CORRIGENDUM-1

e-Tender No. AGL/Head Office/Contract and Purchase/22/25-26/ET/22 [METERING SKIDS] Dated 25.02.2026

PROCUREMENT OF METERING SKIDS

M/s AAVANTIKA GAS LIMITED		
TYPICAL DRAWING FOR PIPE LINE CONSTRUCTION		
PROJECT NAME: TYPICAL DRAWING METERING SKID		
TITL: P&ID FOR METERING SKID 2" FILTER WITH BY PASS		
SCALE	SHEET	DRAWING NO.
NTS	1 OF 1	REV 02

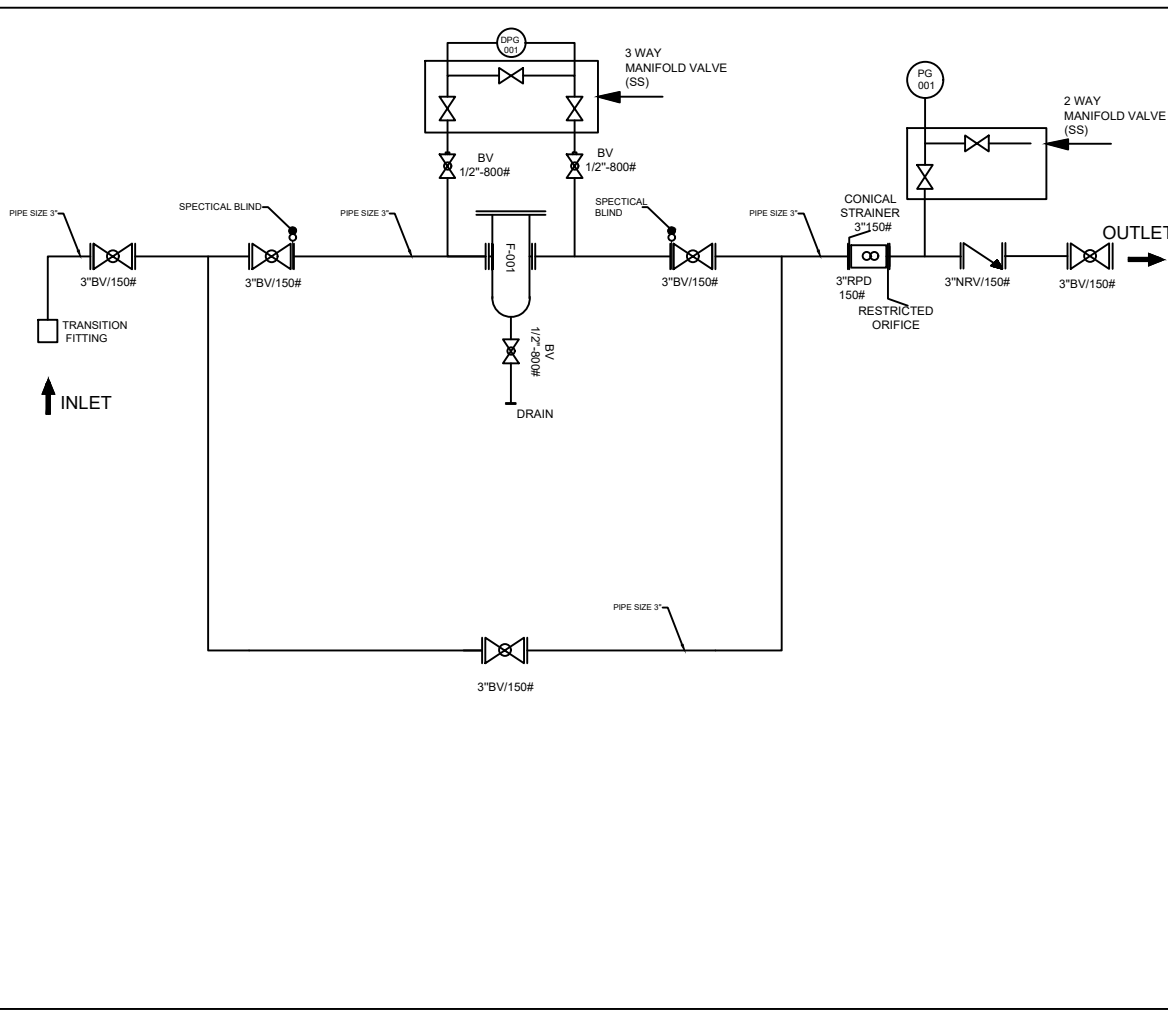
30	Technical		Tender P&ID	We understand that bidder has to follow the MRS line size as mentioned in tender P&ID. Kindly confirm.	Yes, the bidder's understanding is correct. The bidder shall follow the line sizes as per the attached annexures. Example: 2" Skid: Pipeline size is 2" 3" Skid: Pipeline size is 3" 4" Skid: Pipeline size is 4"
31	Technical	49 of 115	Ball Valve - AVL	We request to approved GM Engineering make ball valves for this project. GM is a approved vendor of GAIL, HPCL, ADANI etc. We are regularly supplying GM make ball valves to GAIL in our skids.	Please follow the approved vendor list mentioned in tender
32	Technical		SS fittings - AVL	We request you to approve comfit make SS fittings. Comfit is a approved vendor in all the CGDs.	Tender Condition Prevail
33	Technical	42 of 115	Process parameters	Kindly confirm the process parameters e.g. flowrate , operating pressure for filter sizing. in P&ID operating pressure is different from value given on Pg. 42.	Please follow the below-mentioned criteria for filter design and selection: 2" Skid: Meter size up to G65 3" Skid: Meter sizes G100 and G160 4" Skid: Meter sizes G250 and G400 Maximum operating pressure: 5.5 bar
